GENERAL INFORMATION		
Applicant	City of Camas	
Facility Name and Address	City of Camas Wastewater Treatment Plant P.O. Box 1055 Camas, WA 98507	
Type of Treatment	Activated sludge with filtration capability and UV disinfection	
Discharge Location	Columbia River Latitude: 45° 34' 36" N Longitude: 122° 23' 28" W.	
Water Body ID Number	Old ID No. WA-CR-1010, New ID No. 1220169456238

APPENDIX D-RESPONSE TO COMMENTS

Dilution Ratios Based on Updated Modeling Results:

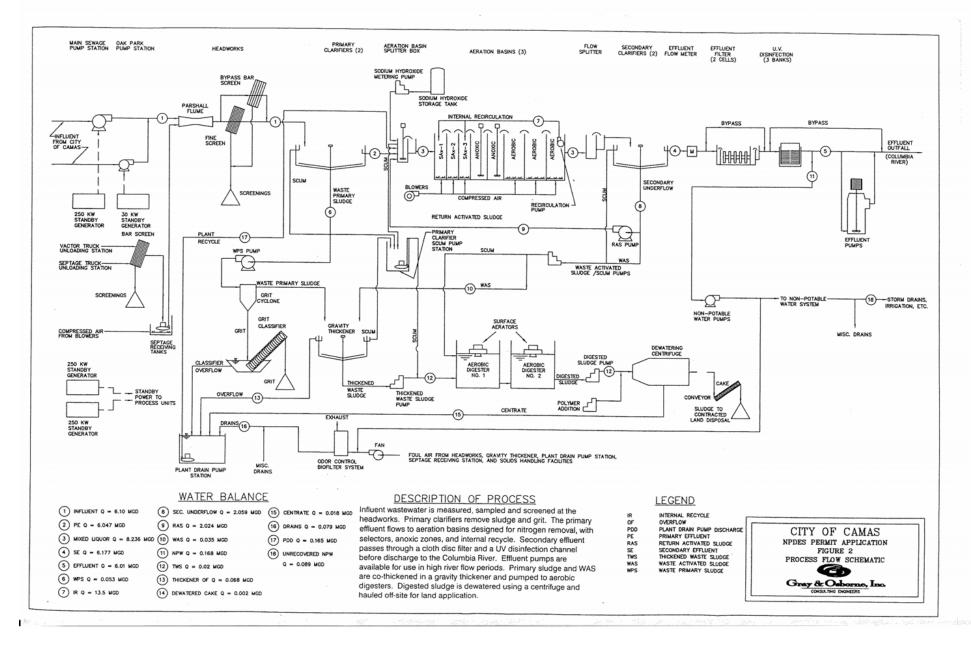
Fact Sheet, Page 37: The 1994 Wastewater Facilities Plan for the City of Camas analyzed the treatment plant discharge diffuser with the computer software model UDKHDEN. As reported in the current Fact Sheet, the Washington State Department of Ecology (WDOE) in 2004 ran a new series of modeling scenarios utilizing the UM3 model. According to WDOE the reason for changing the model was that UDKHDEN "tends to over predict the dilution compared to the UM3 model for these waters. The model also used a flux average model prediction rather than a centerline prediction which is recommended in the Department guidance for unidirectional water."

The City's consultant, Gray & Osborne, Inc., modeled the City of Camas diffuser using the CORMIX mixing zone model with the identical input values used by WDOE based on the draft NPDES Permit, Fact Sheet, and hard copy UM3 model runs provided by WDOE (see attached CORMIX model run data). In addition, Gray & Osborne checked their CORMIX model results by having Dr. Robert Doneker, P.E., (Portland State University) a developer of the CORMIX model, independently model the Camas diffuser (see Dr. Doneker letter attached). The dilution results are characterized below for both the UM3 and CORMIX models based on *Table C6: Predicted Dilutions for the City of Camas*, contained within the NPDES Fact Sheet.

In the model run NC22B, the input parameters of the small discharge velocity relative to the high ambient velocity will provide wake-like conditions without any jet mixing. This wake attachment is a dynamic interaction of the effluent plume with the bottom that is forced by the receiving water crossflow. This is an actual physical condition that occurs with these input variables. The UM3 model or other similar models do no have the capability to predict that this process is even occurring. The dilution values derived from the UM3 modeling for model run NC22B are not valid since UM3 is not capable of modeling this known physical process.

- 4. The ambient flow rate (3017.49 m3/s = 106561 cfs, see output "session report") used in CORMIX2 analyses (see Case NC9)was much lower compared to the flow rate (192,000 cfs) used in UM3 analyses. This would imply that the ambient river dimensions are wrong assuming that the ambient current used was correct. Other cases were not checked.

- 6. In model run NC22B the discharge velocity at each port is 76 percent of the ambient velocity which is not a relatively small number as alluded to in the comments
- 7. There was also a comment suggesting the presence of local recirculation at the outfall and that this would lead to re-entrainment of already mixed water back into the buoyant jet region. First, there was no physical basis provided to indicate presence of local recirculation. Secondly, the re-entrainment of already mixed water would tend to reduce dilution factor compared to entrainment of ambient water that has not previously mixed with the effluent. Thirdly, the plume is not buoyant as eluded to (see Case NC9).
